ADDENDUM NO. 4

Reference: Various Energy Upgrades – Weber Valley Detention Center
Division of Juvenile Justice Services – Roy, Utah
DFCM Project No. 11023430

MECHANICAL ADDENDUM # 2

Chiller Replacement & Stand-alone HVAC Unit

MAIN FLOOR
MECHANICAL PLAN
M101

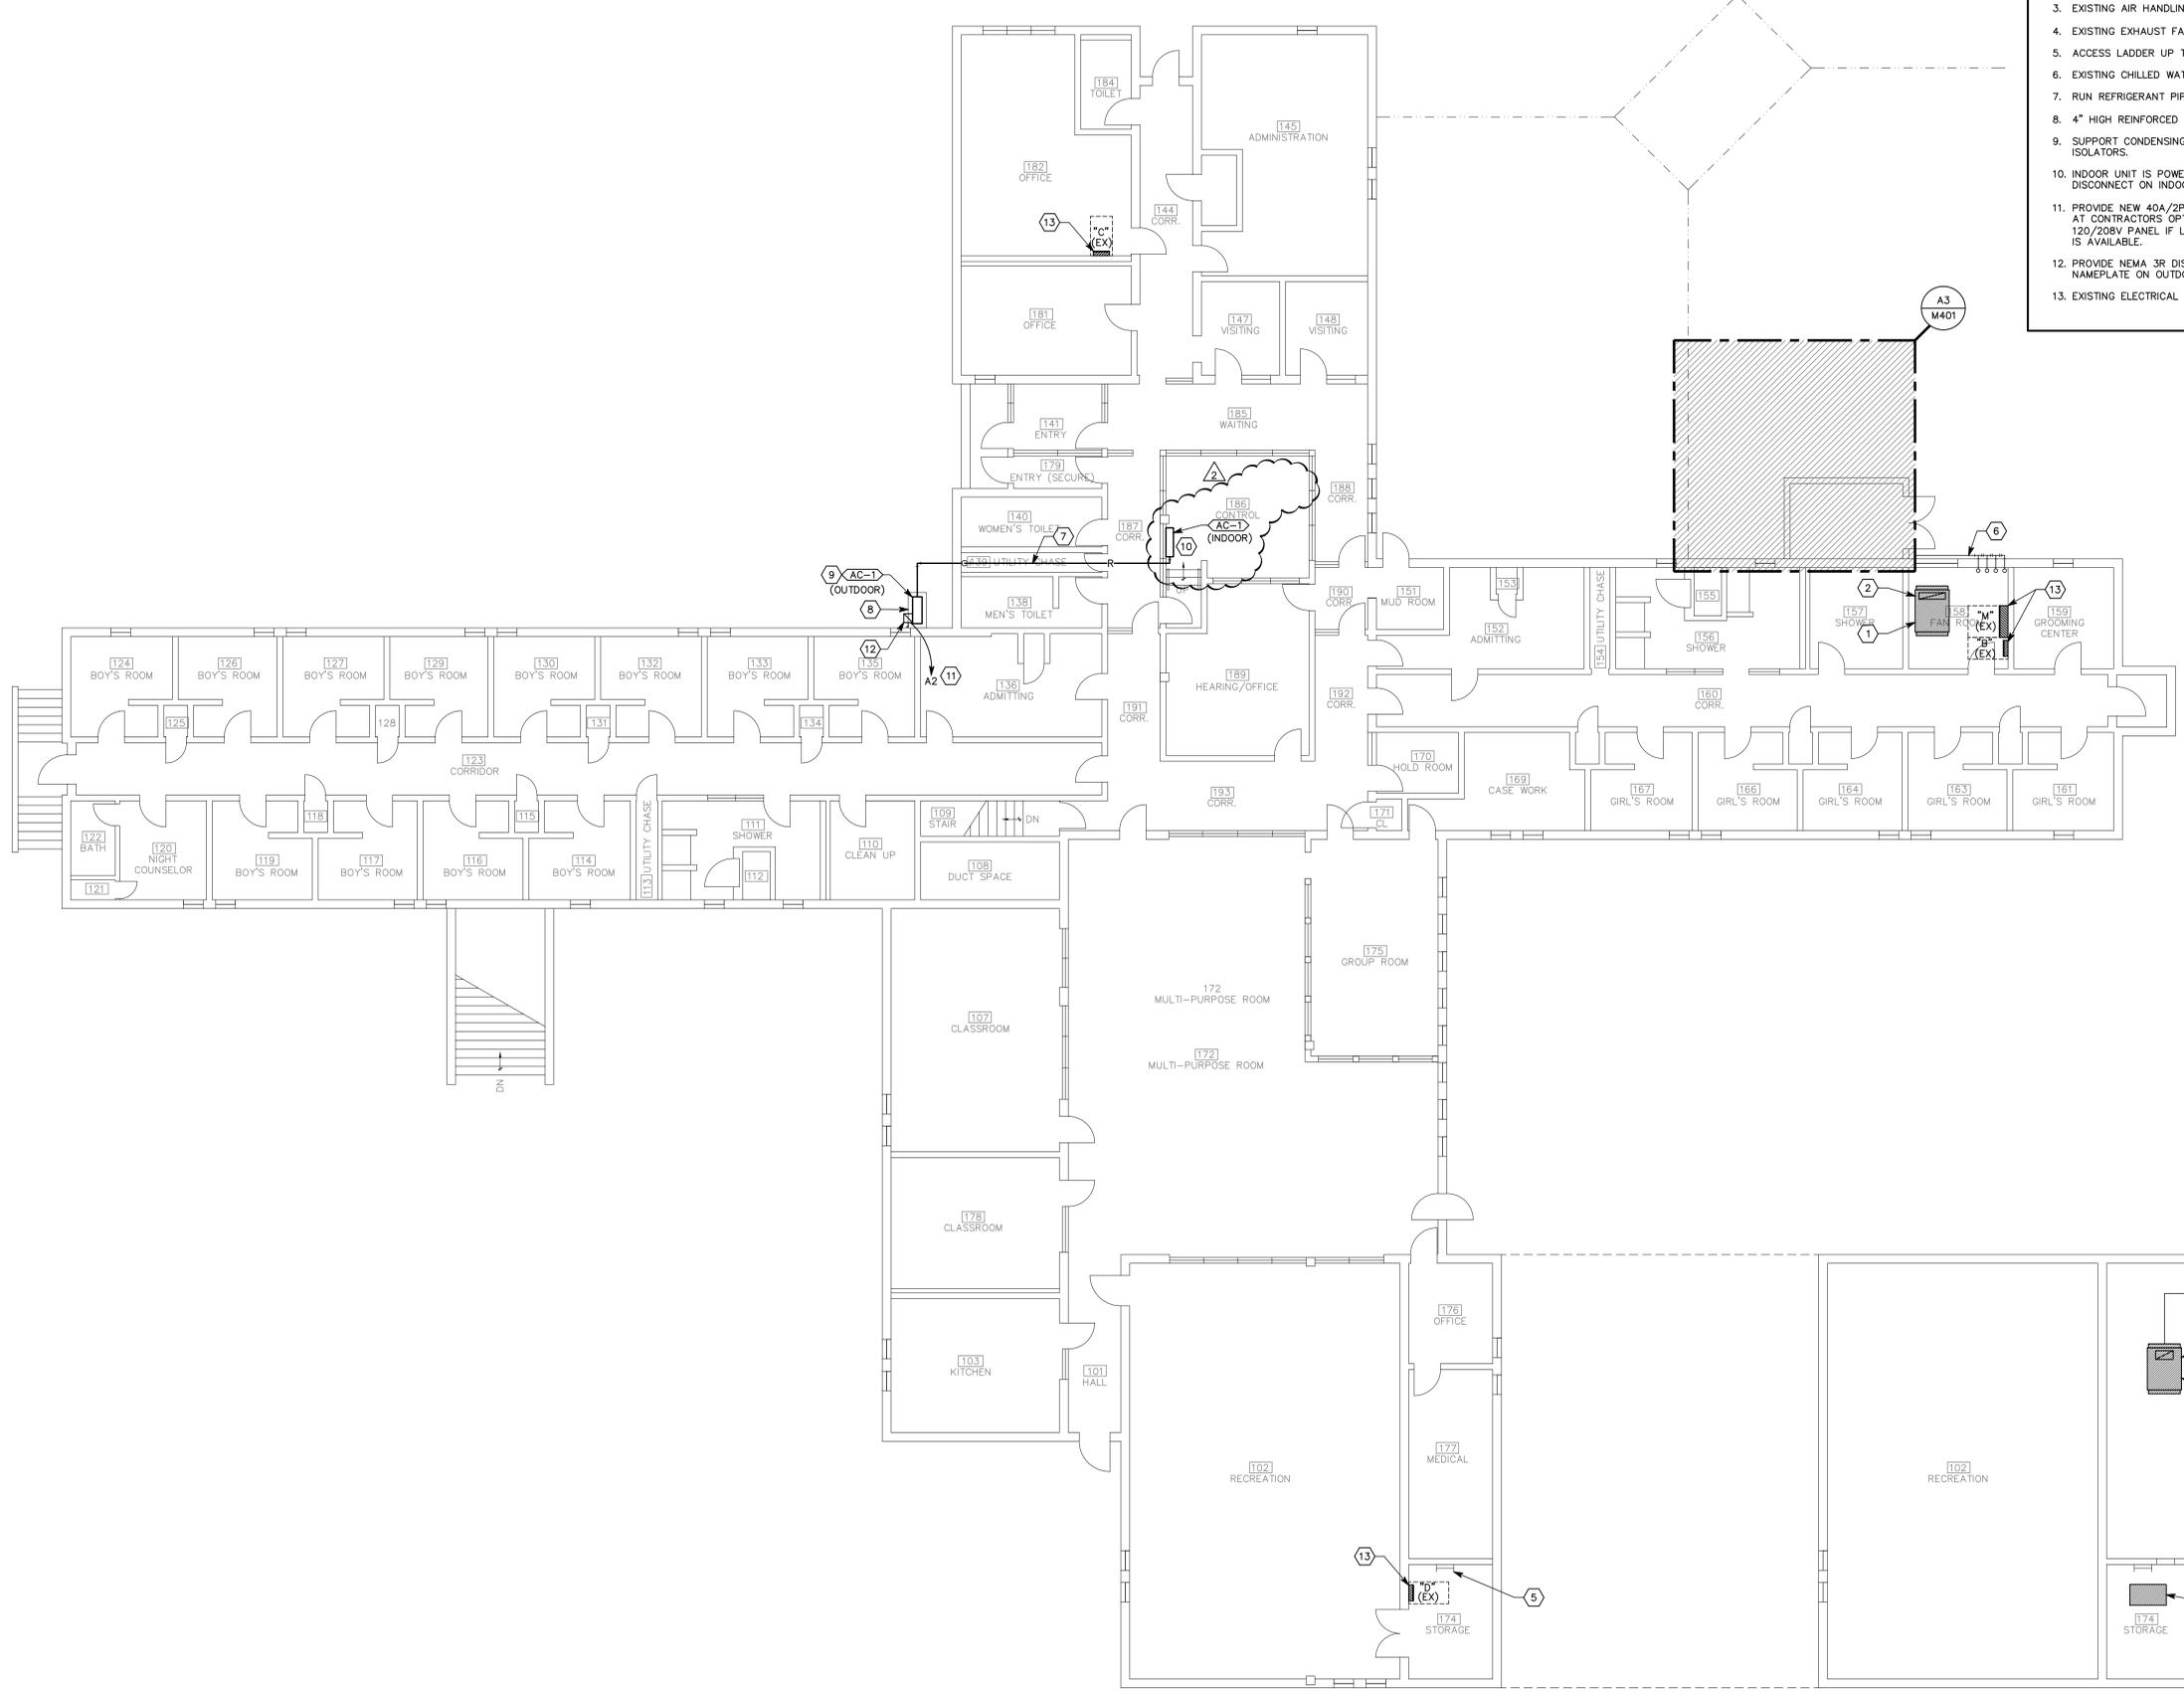
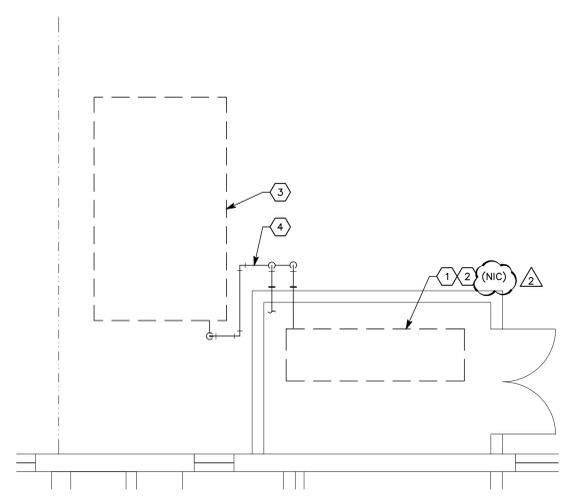
- c. ECM-3 New Heating & Air Conditioning Unit for Control Room **IS** part of this project.
 - i. Delete ceiling diffuser and ceiling grill in existing control room

- ii. Remove existing thermostat from control room and relocate to hearing office 189.
 - iii. Cap existing supply air and return air ductwork serving control room

- iv. Provide new split-system heating and air conditioning unit for control room.
 - d. ECM-4 Revised sequence of operation for hot water & chilled water pumps is **NOT** part of this project. Disregard any reference to revising the controls on this project.

ENLARGED
MECHANICAL PLAN
M401

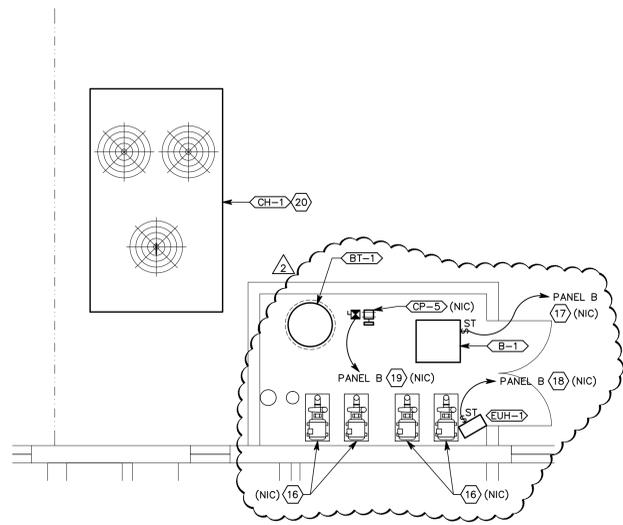
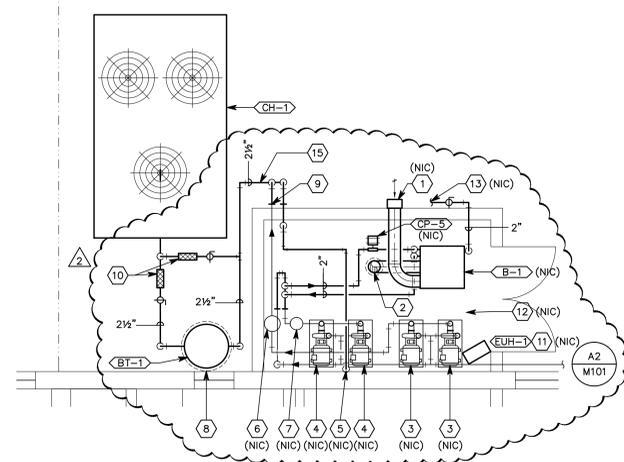
- j. ECM-10 Replace existing chiller IS part of this project
 - i. Remove existing chiller.
 - ii. Remove existing exterior chilled water piping
 - iii. Install new chiller.

- iv. Install new chilled water buffer tank.
 - v. Provide new chilled water piping between chiller, buffer tank and existing chiller
 - k. ECM-11 Install Low Flow Devices on Plumbing Fixtures is **NOT** part of this project

2. Contractor is responsible for removing and disposing of the existing chiller and associated existing chilled water piping indicated on the drawings.
